Technical change to RJ45 CabinetLine

- PCN-number: PCN-PB47-20180213-00-A
- date of publishing: 13th of February 2018 / Update 18th of June 2018
- revision number: B

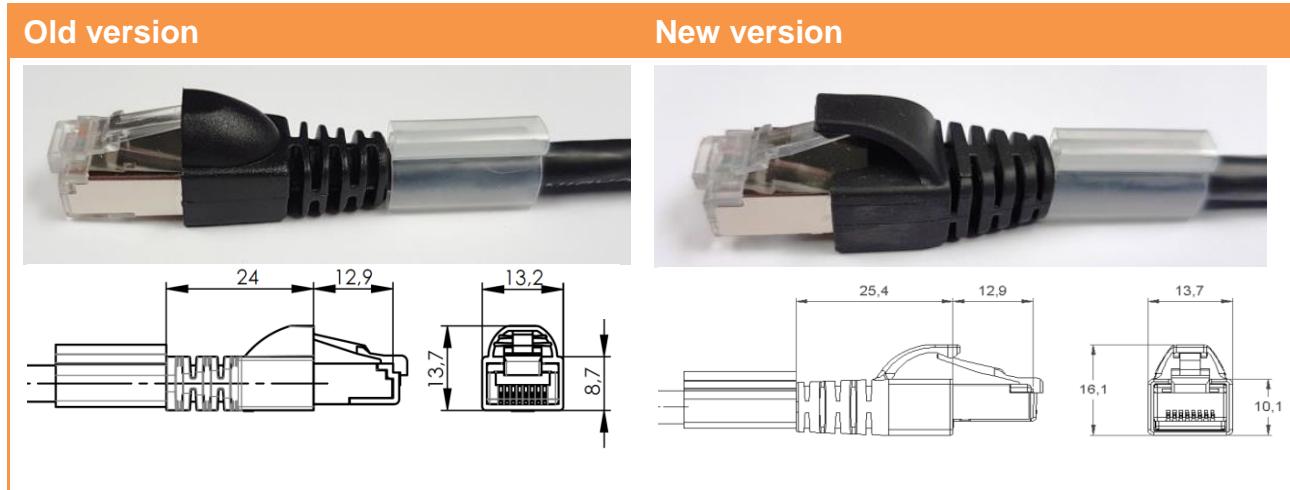
- The RJ45 connector moulding has a new design and material (PUR).
- Furthermore, we added cable printing for a better identification after installation of the patch cord.
- With regard to the technical requirements the new CabinetLine meets the same tests as the old version.
- Furthermore color deviations may occur.

Improve the handling of the latch protection especially by low temperatures.
